Mod2018/0232

Project: MODIFICATION SEC.4-55
PROPOSED ALTERATIONS AND ADDITIONS
TO AN EXISTING DWELING AT
17 MINKARA RD. BAYVIEW

Title: GROUND FLOOR PLAN

Dwg No. DA 2 A

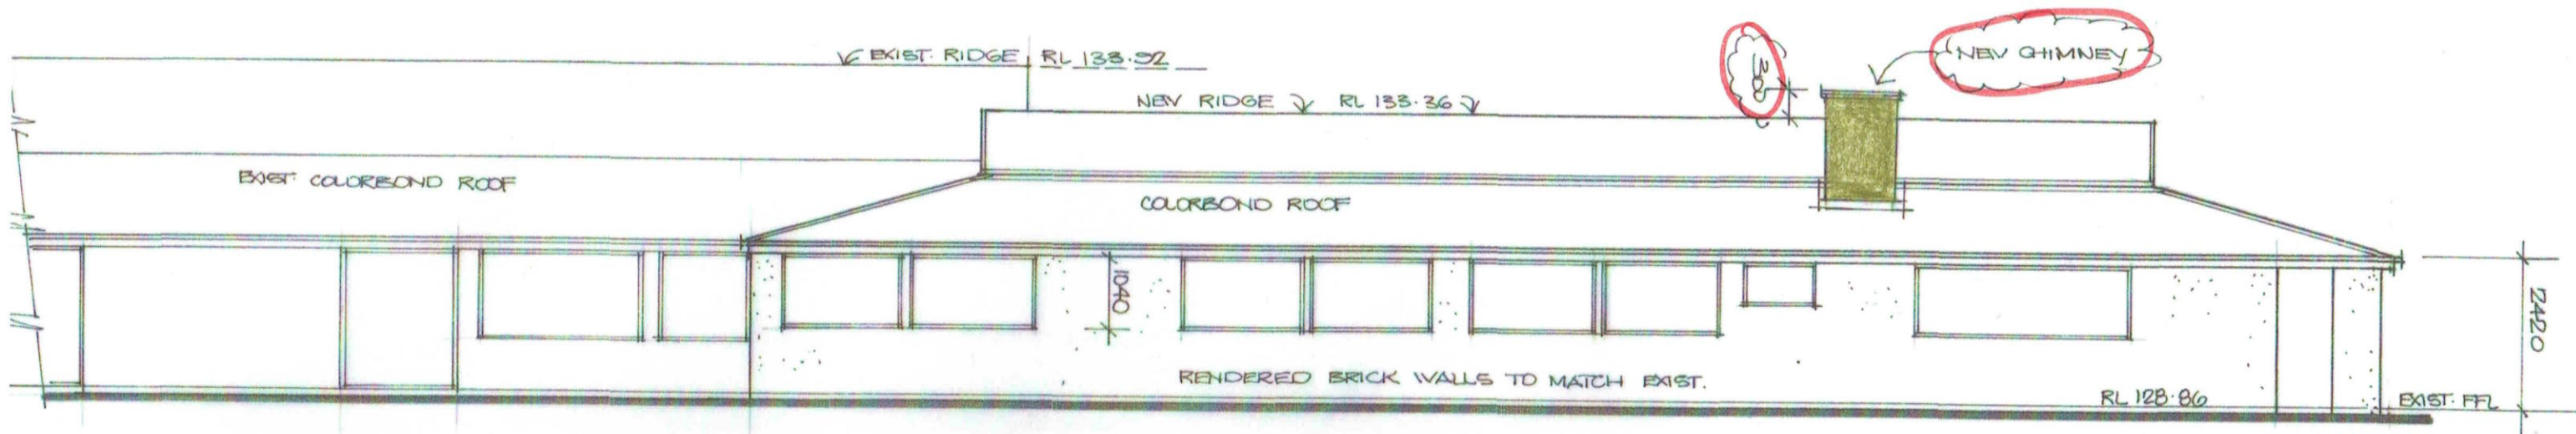
MAY 2018 - 'A' - GAS FIREPLACE ADDED

Dwg No. DA 4A

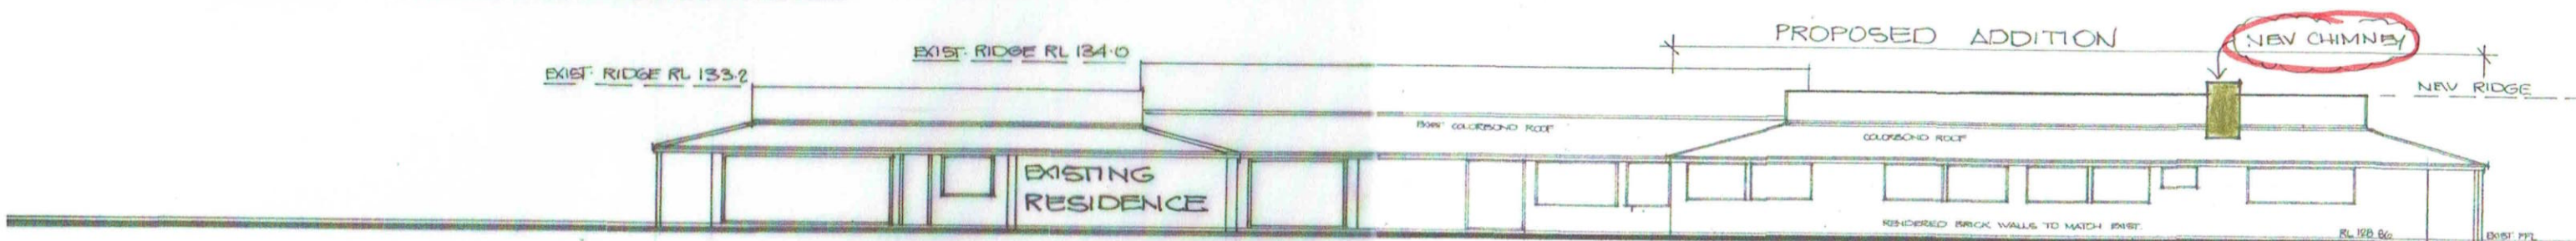
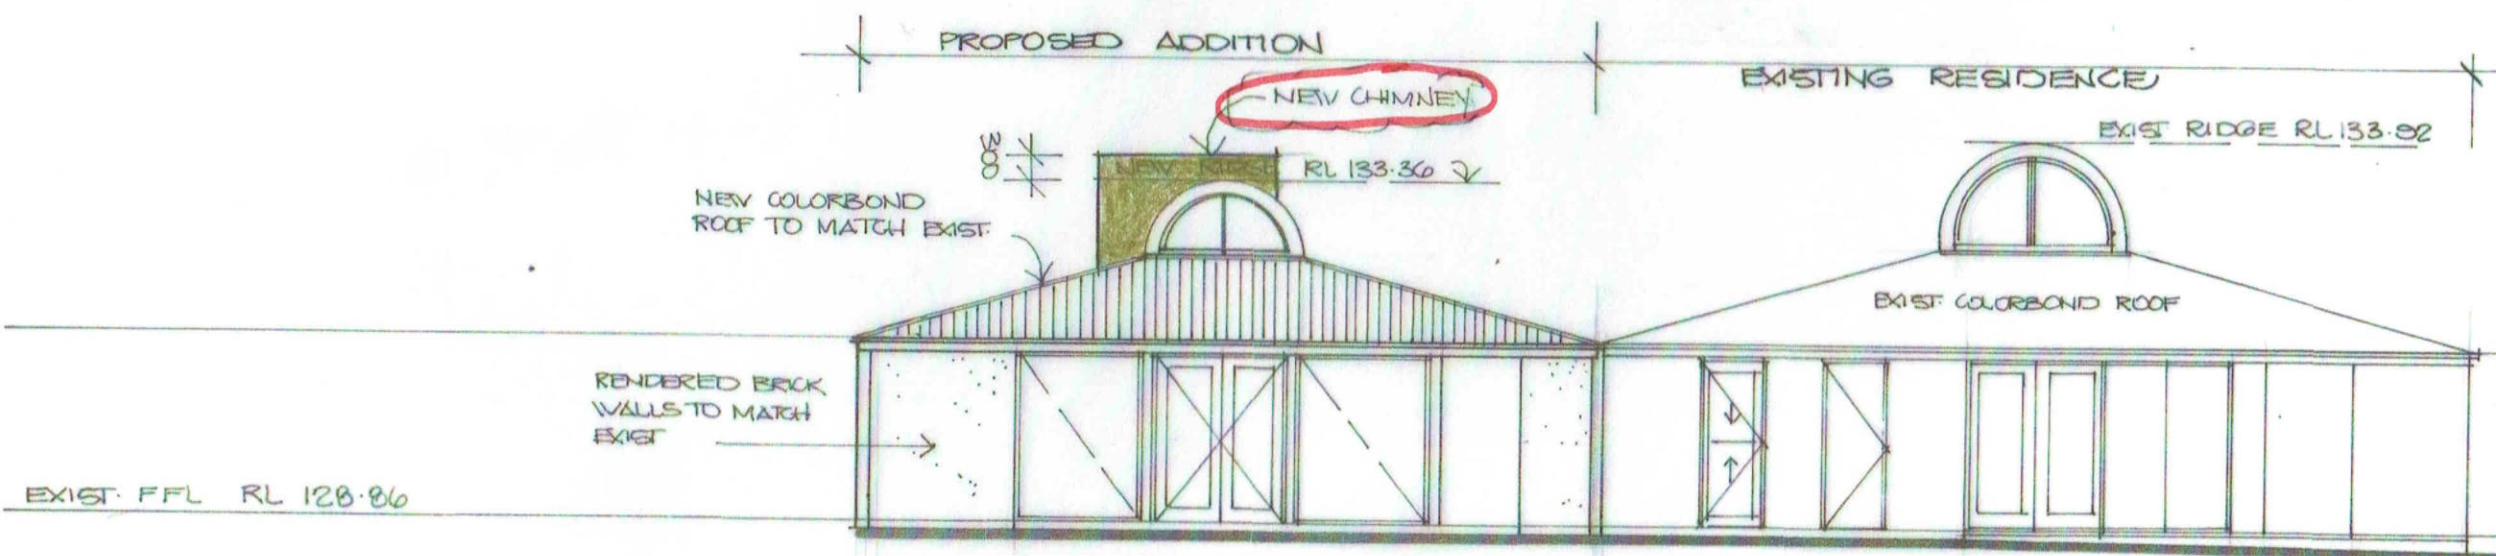
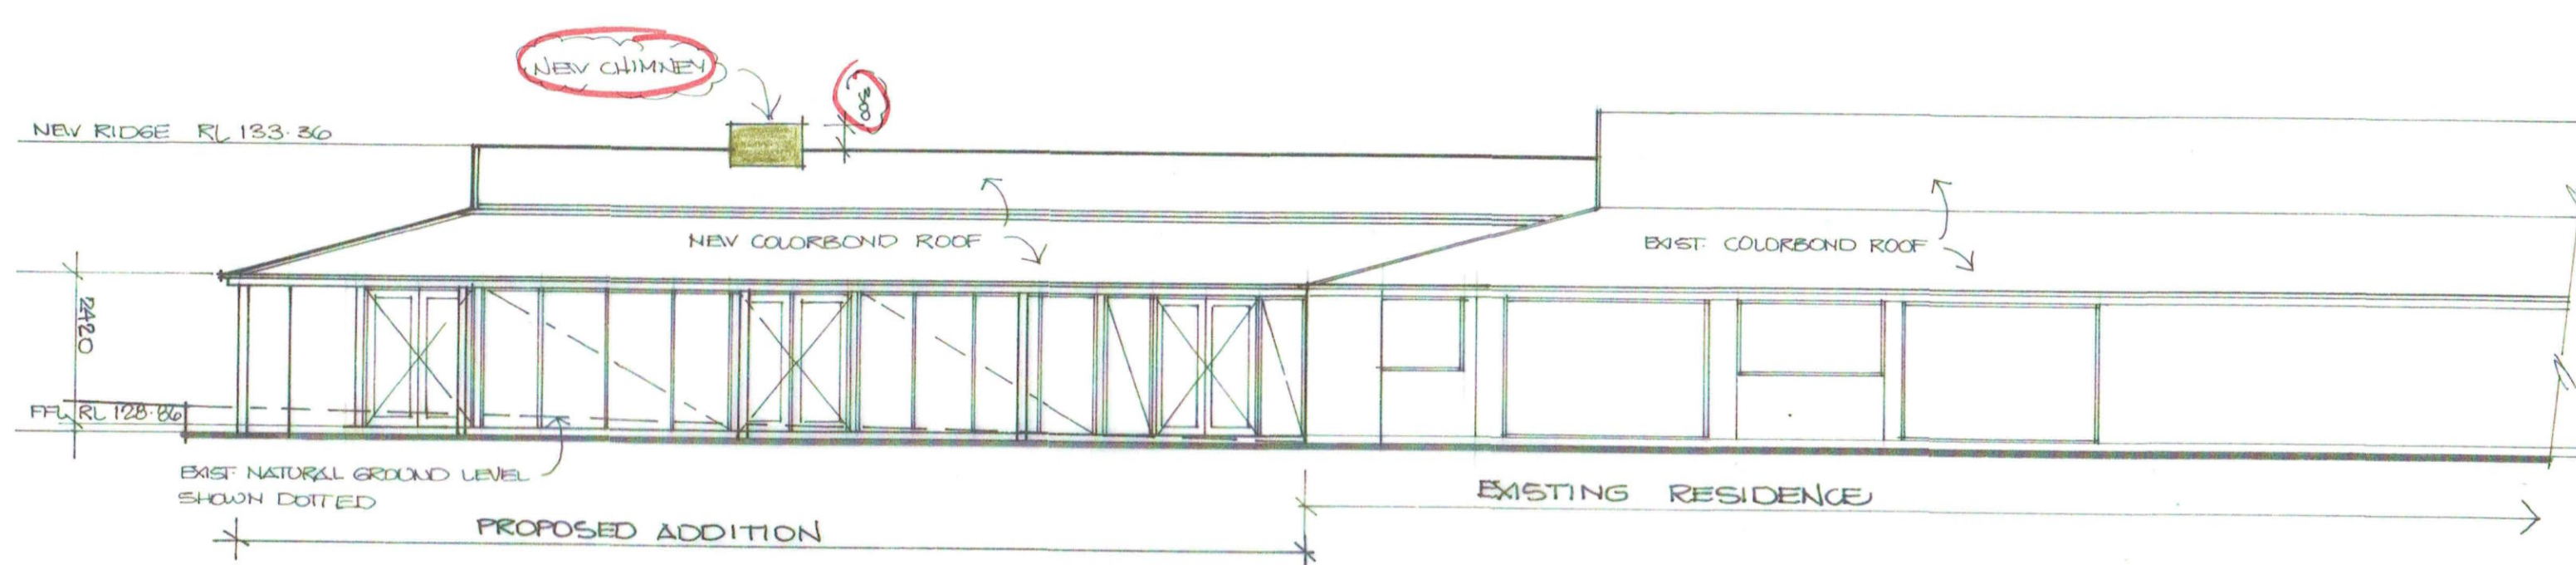
MAY 2018 - A - CHIMNEY ADDED

Dwg No. DA 5A

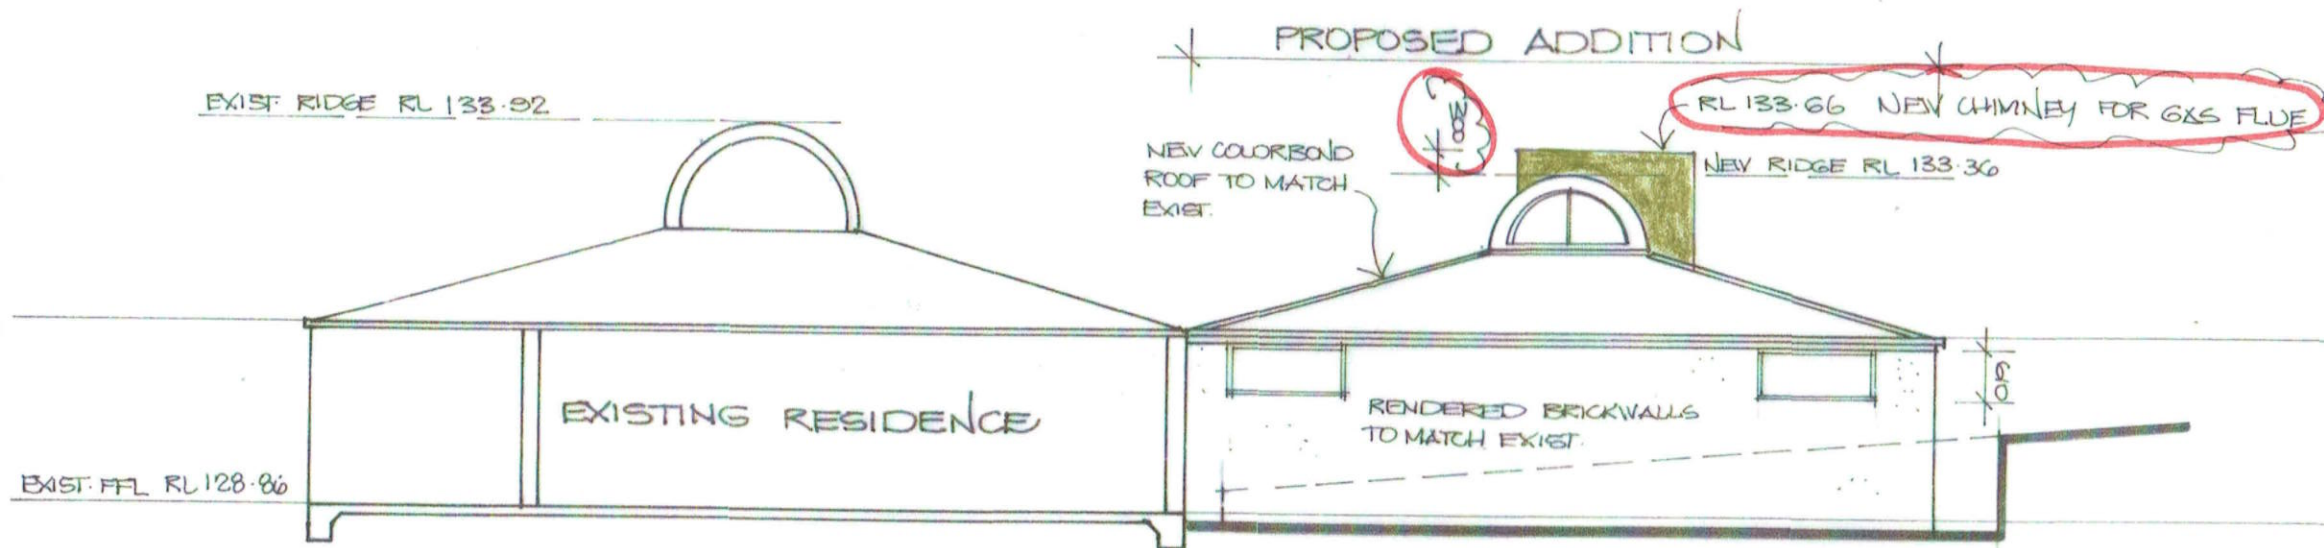
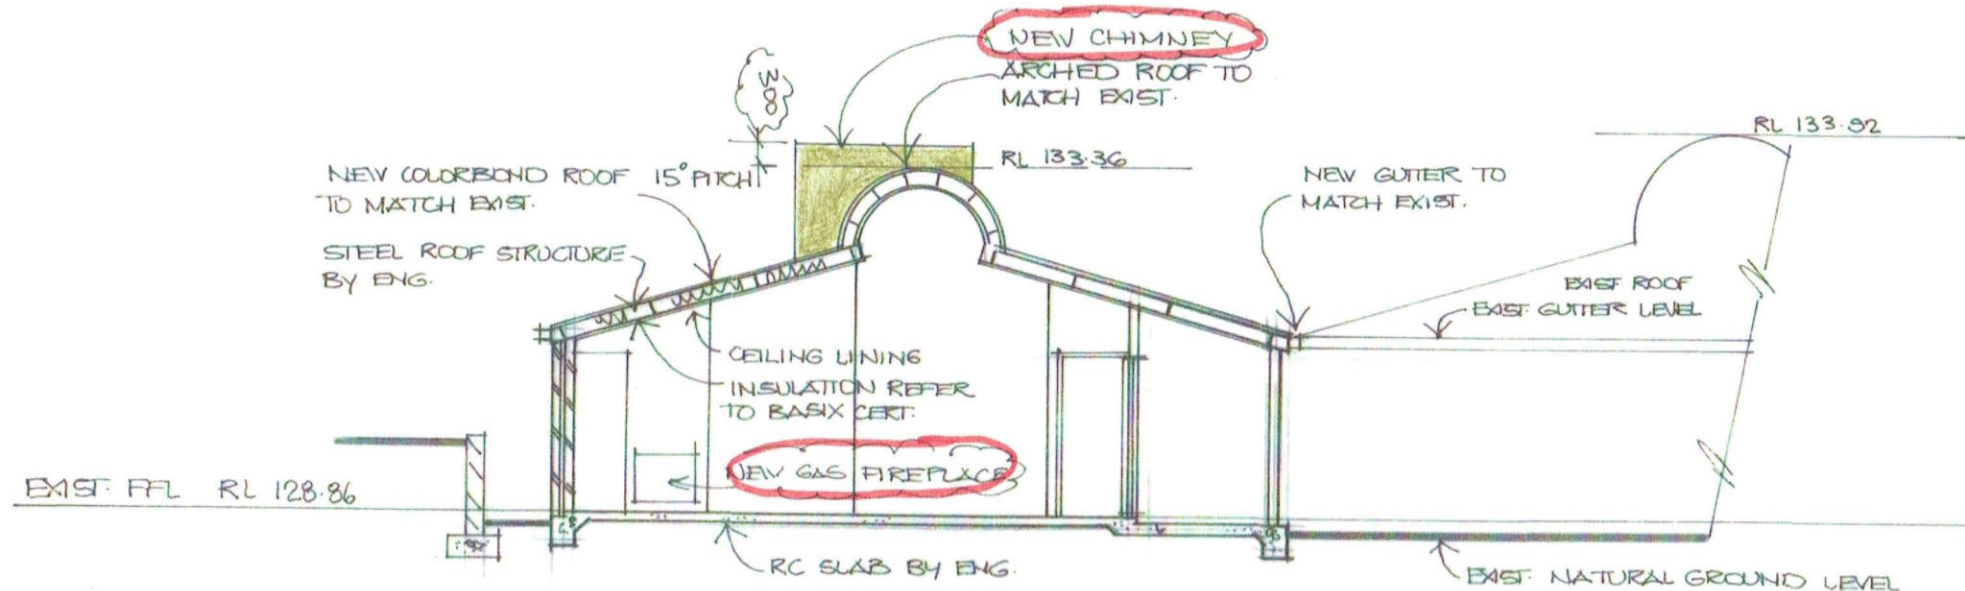
MAY 2018 - A - CHIMNEY ADDED
